Final Set, Jefferson Village Phase II  
(Bulletin 6)

JEFFERSON VILLAGE

TYPICAL PAVEMENT CROSS SECTIONS

HOR. SCALE: NO SCALE  
VER. SCALE: NO SCALE  
DATE: 3-27-00  
JOB NO.: DE99011  
FILE NO.: DE9911X1  
SHEET NO.: P-0.2

INTERSECTION DETAILS  
 MARQUETTE AVE.

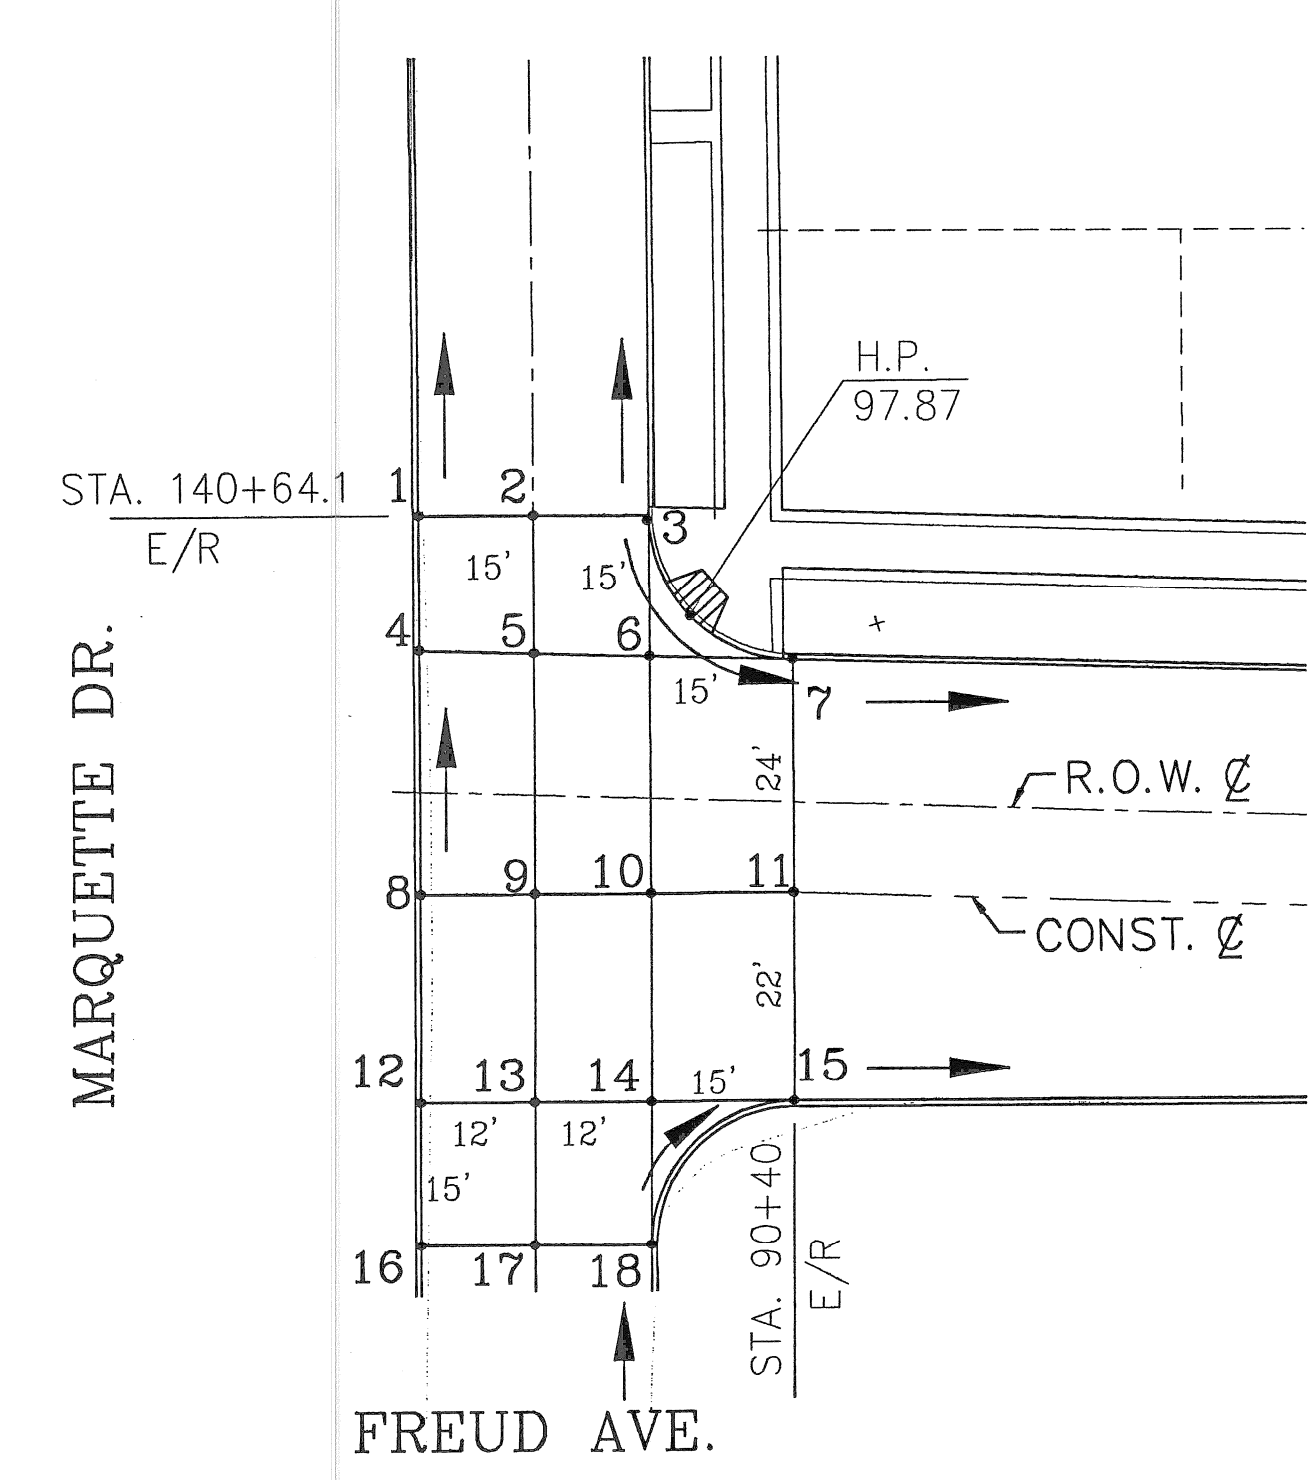
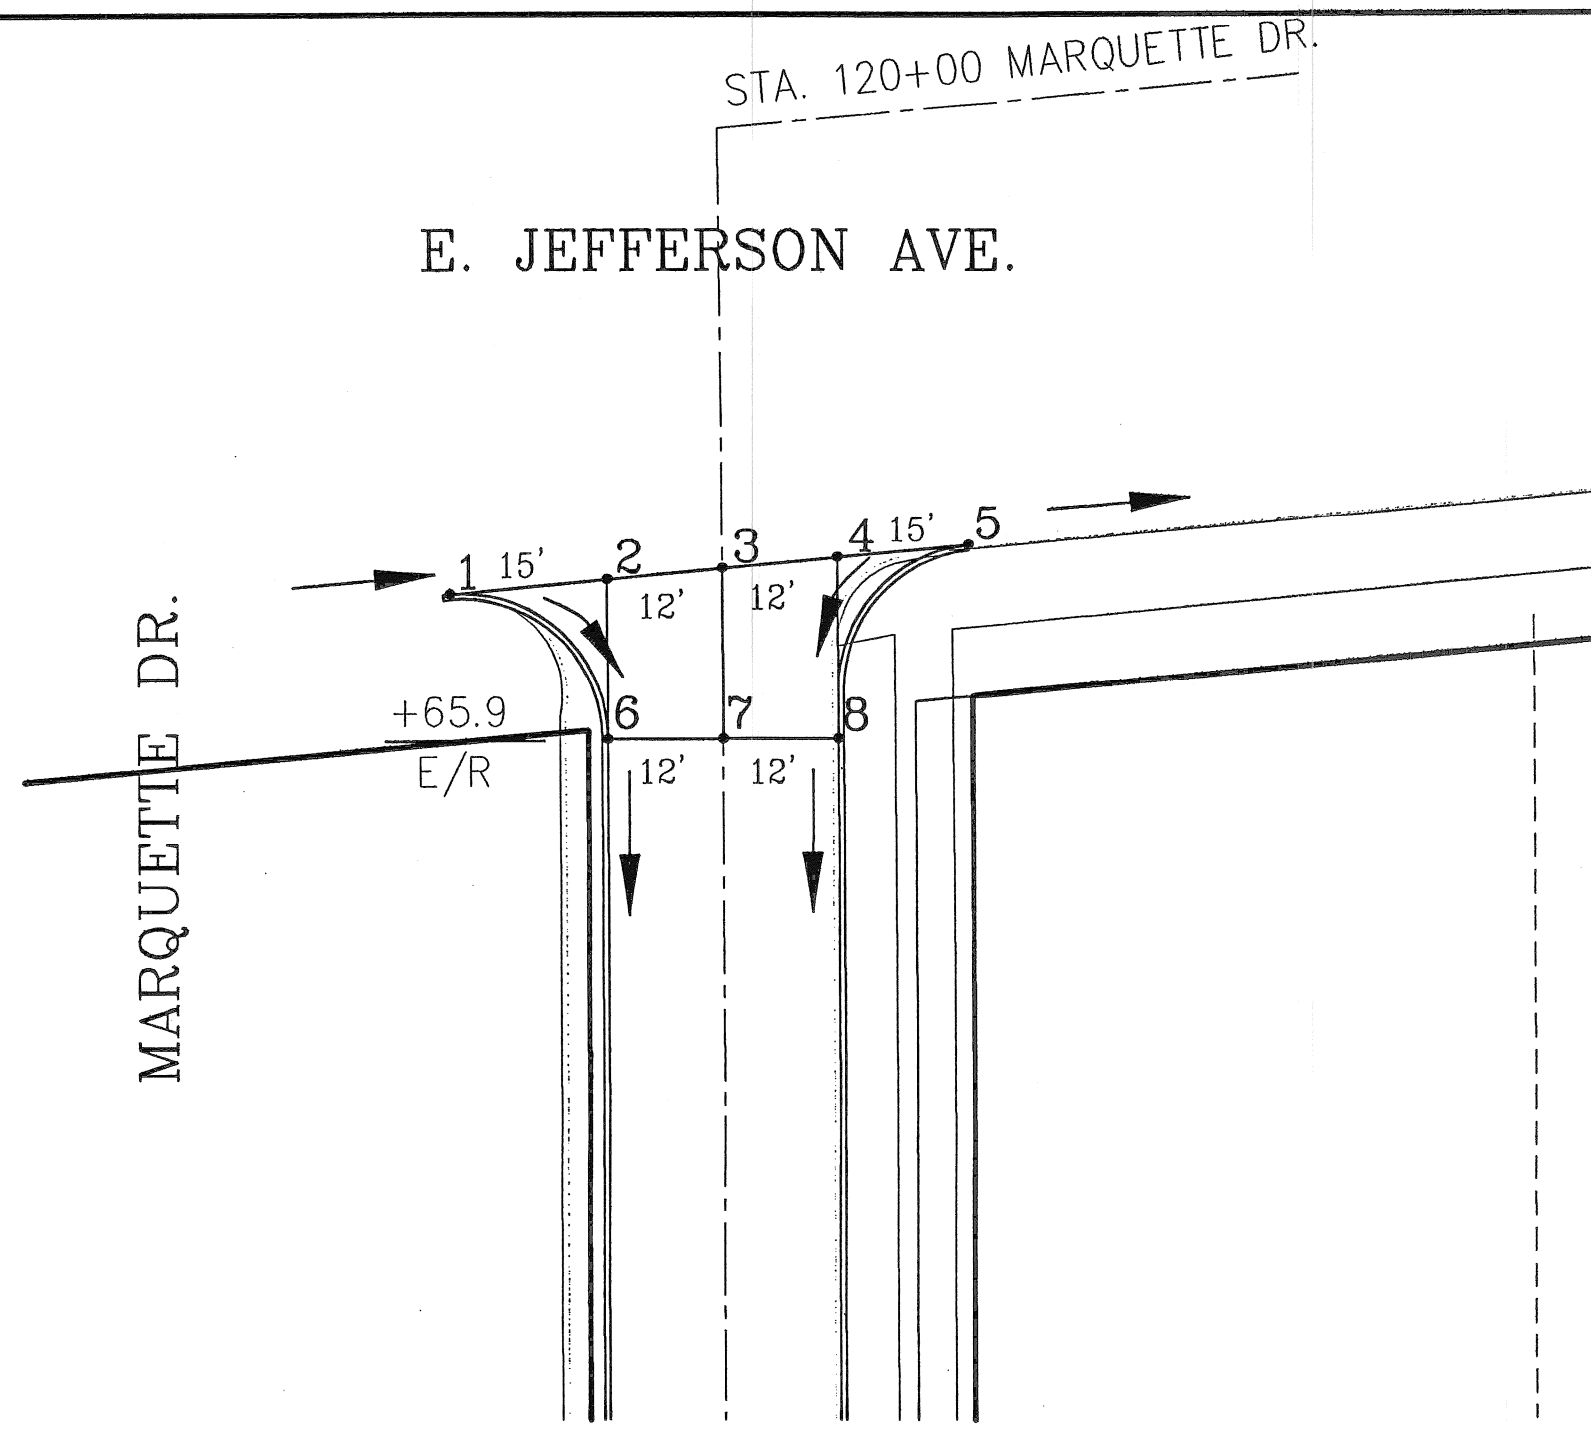
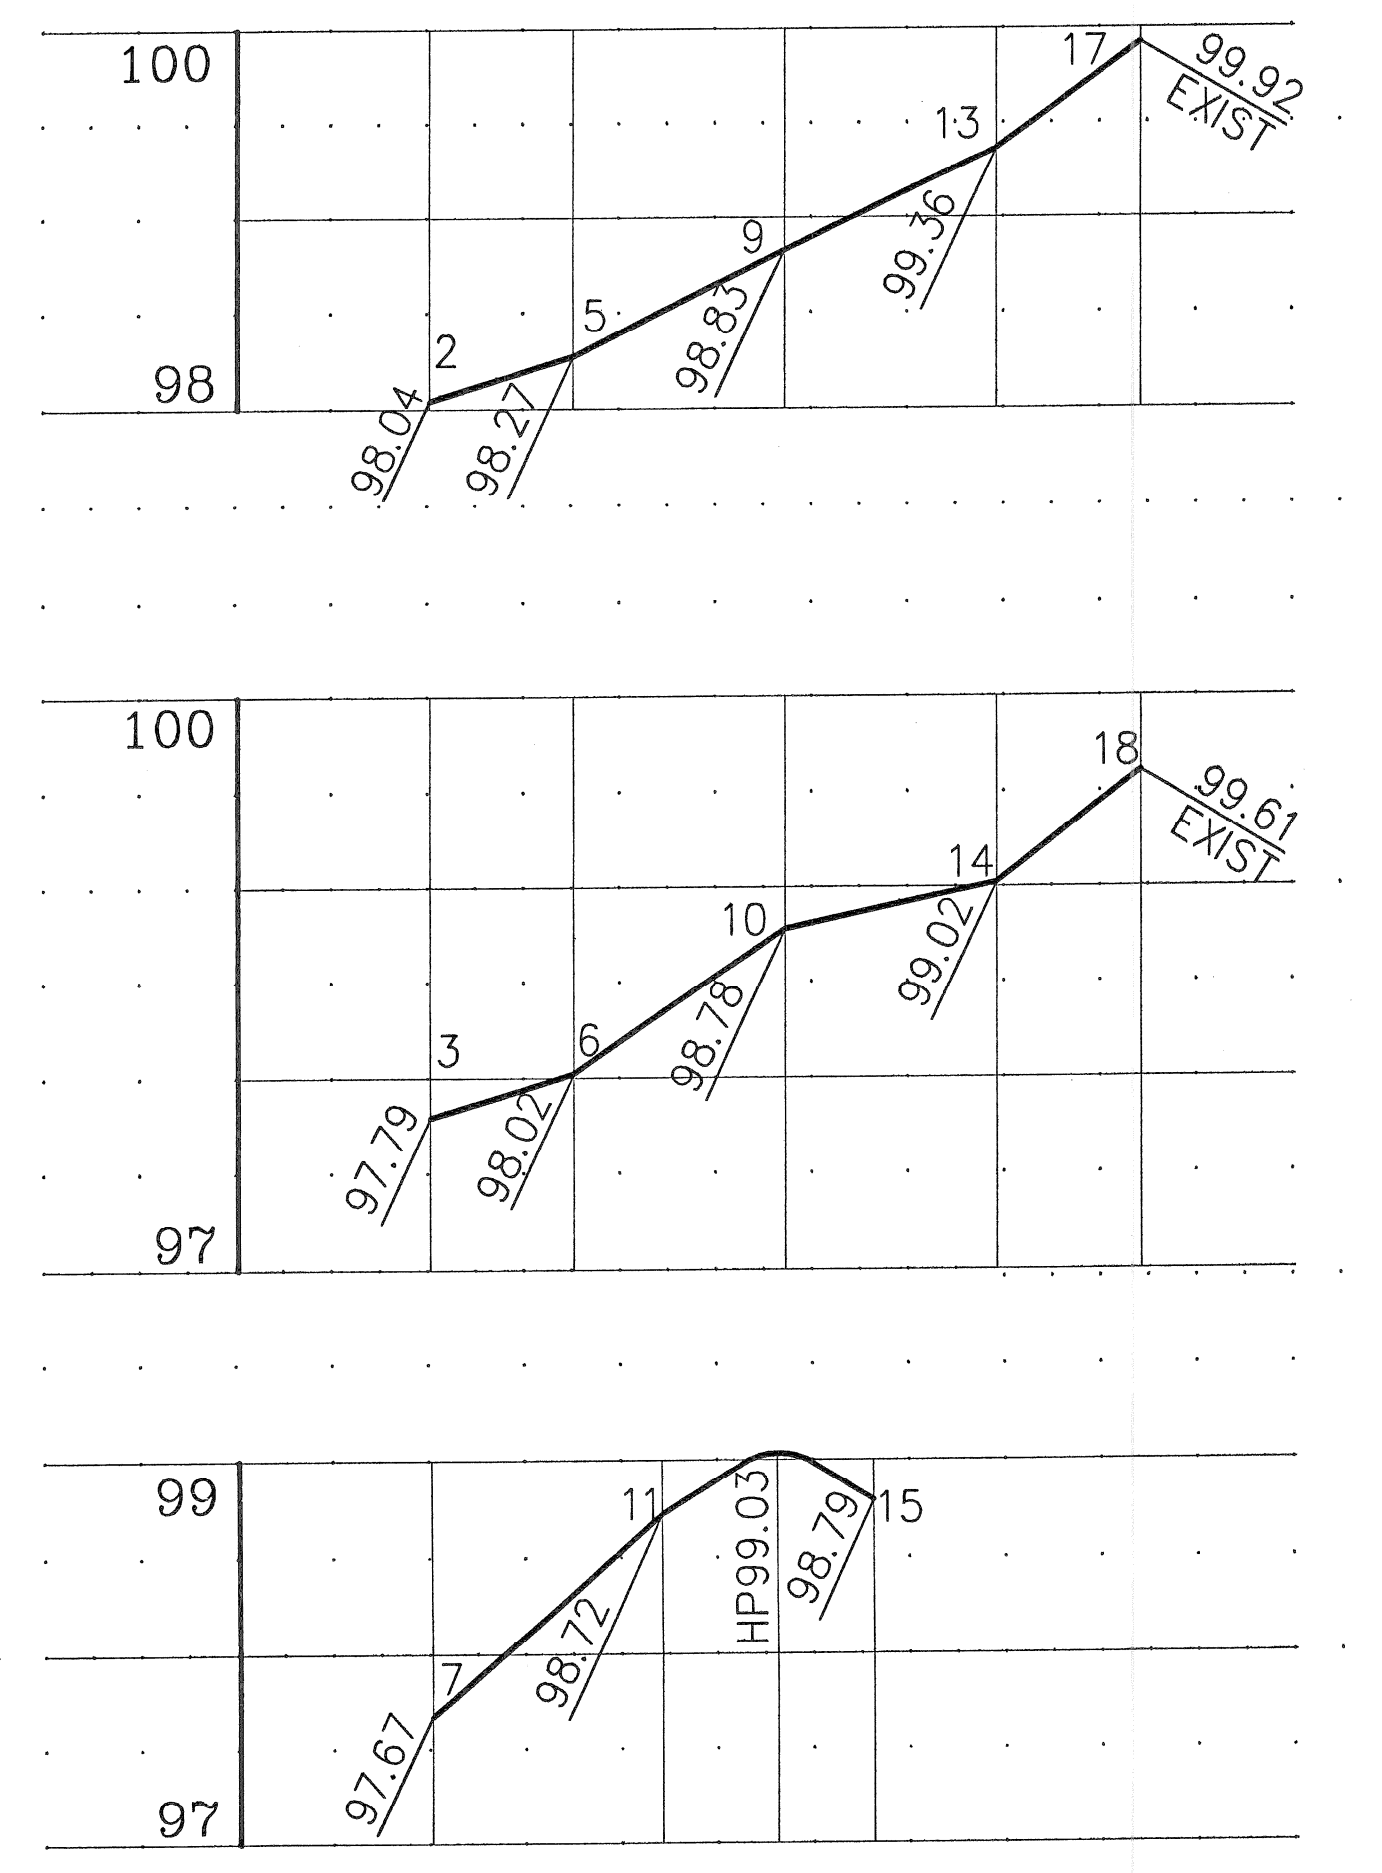
**NOTE:**  
 WHERE PROPOSED ROLL CURB TIES INTO EXISTING CURB/7" HIGH CURB THE CONTRACTOR SHALL TAPER DIMENSIONS OF THE PROPOSED CURB OVER A LENGTH OF FIVE (5) FEET TO MATCH THE EXISTING/7" HIGH TOP OF CURB, FACE OF CURB AND BACK OF CURB. PAYMENT FOR THIS WORK SHALL BE CONSIDERED AS BEING INCLUDED IN THE COST FOR ALL OTHER CONCRETE PAVEMENT WORK.
